IBC - Fire Safety

2024 GROUP A PROPOSED CHANGES TO THE I-CODES

Committee Action Hearings (CAH #2)
October 23 - 31, 2024
Long Beach Convention Center
Long Beach, CA

Figure 15.24 from the SFPE Handbook of Fire Protection Engineering – Fifth Edition.

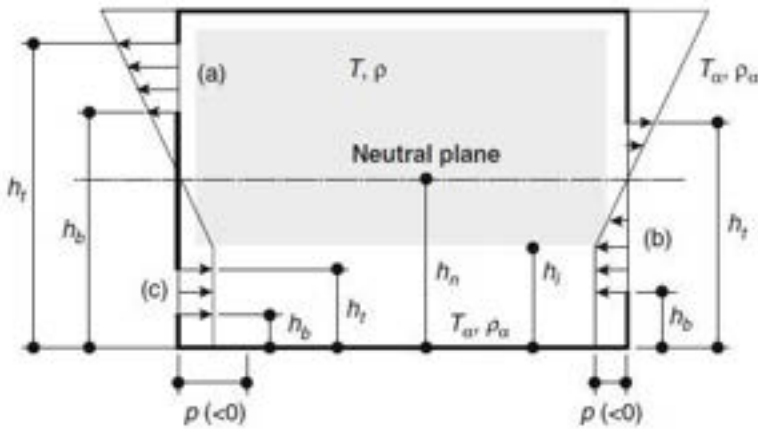
During a fire, the room of origin becomes positively pressurized above the neutral plane and negatively pressurized below the neutral plane. As such, fire, smoke and superheated gasses will rarely if ever migrate from the room of origin into adjacent spaces at the bottom of a wall and protection at the bottom of the wall contradicts the physics of the requirement.

Fig. 50.6 Smoke movement in a high rise building due to normal stack effect

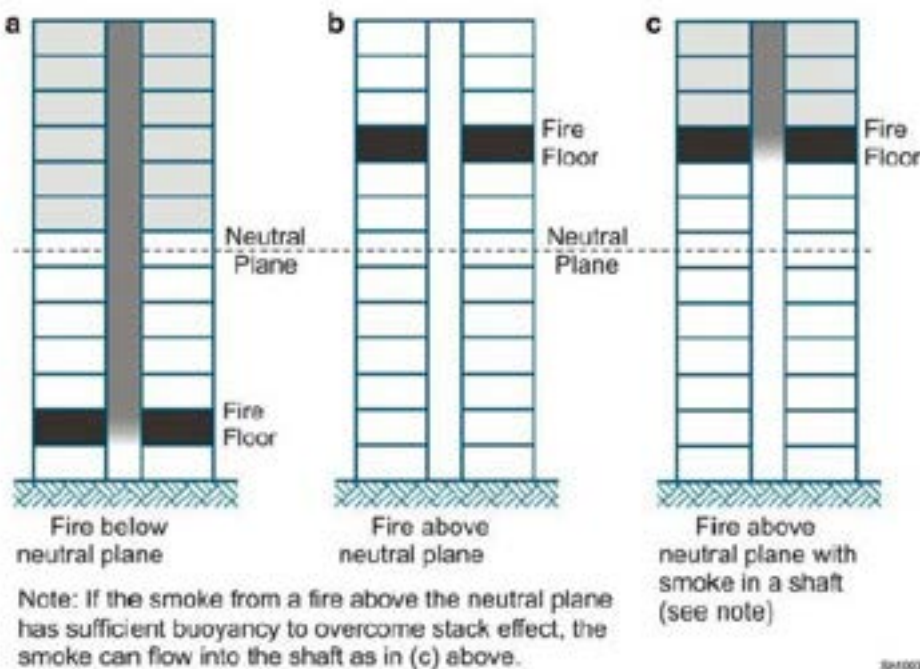
A shaft or other wall that abuts two or more interconnected levels may experience leakage through the gap at the bottom of a wall sufficient to allow migration of fire, smoke or superheated gasses as demonstrated in the figure included with this comment, which is from the SFPE Handbook of Fire Protection Engineering – Fifth Edition.

FIGURE 1402.3 Wind-driven rain wind speed (m/s) hazard map to determine ASTM E331 test pressure criteria [1 m/s = 2.24 mph]

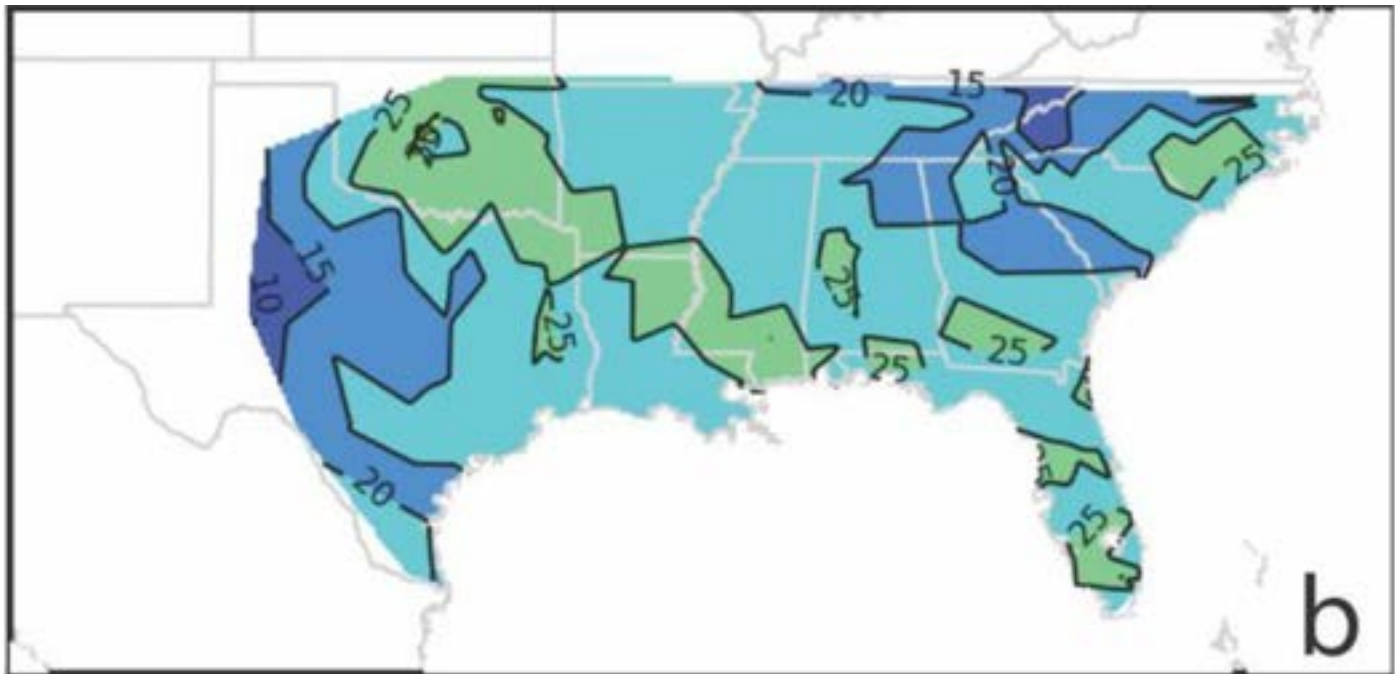
Reason: The code lacks a risk-consistent basis for addressing wind-driven rain and resistance to water intrusion. This proposal provides a wind-driven rain hazard map (Figure 1402.3) that properly characterizes the hazard as it varies across wind-driven rain climatology of the U.S. This map of the southeastern U.S. is a placeholder until a map of the entire U.S. becomes available in 2024.

The proposal “permits” and does not mandate use of proposed Section 1402.3, the wind-driven rain map of Figure 1402.3, or the associated ASTM E331 test pressures of Table 1402.3. Instead, the reference to Section 1402.3 in Section 1402.2 uses permissive language (“shall be permitted”) to allow for current practice to continue unchanged for existing materials and methods recognized in the code. This optional or voluntary approach will allow time for various stake-holders and standards developers to align their standards with this new risk-based approach without changing requirements for materials and methods currently recognized in the code at this time.

Reason: This proposal was disapproved at CAH#1 at the request of the proponent to allow time for additional work on the wind-drive rain map (Figure 1402.3) to be completed. This modified proposal provides flexibility to use an "approved source" in lieu of the mapped wind-driven rain wind speeds of proposed Figure 1402.3 given its limited scope of the southeastern U.S. Otherwise the proposal is unchanged. The intent remains to replace the southeastern US map in Figure 1402.3 with a full US map, but the NOAA-funded research at Cornell University was not completed in time for this comment submission. Therefore, the map replacement may occur as a modification during CAH#2. If not, it will be addressed during the public comment phase.

1. The ASTM E331 test pressure shall be determined in accordance with Table 1402.3 and Figure 1402.3 or by calculations in accordance with ASCE 7 using a design wind-driven rain wind speed in accordance with Figure 1402.3 or an approved source. The test pressure shall not be less than 2.86 psf (137 Pa) and shall not be required to exceed 12.0 psf (575 Pa).
2. The duration of test shall not be less than 15 minutes. Subsequent tests with increased test pressure shall be permitted with leakage assessment after each test.
3. The tested assembly shall be considered to resist wind-driven rain at the greatest test pressure increment where water did not penetrate the innermost layer intended to provide water resistance protection of the remainder of the wall assembly.
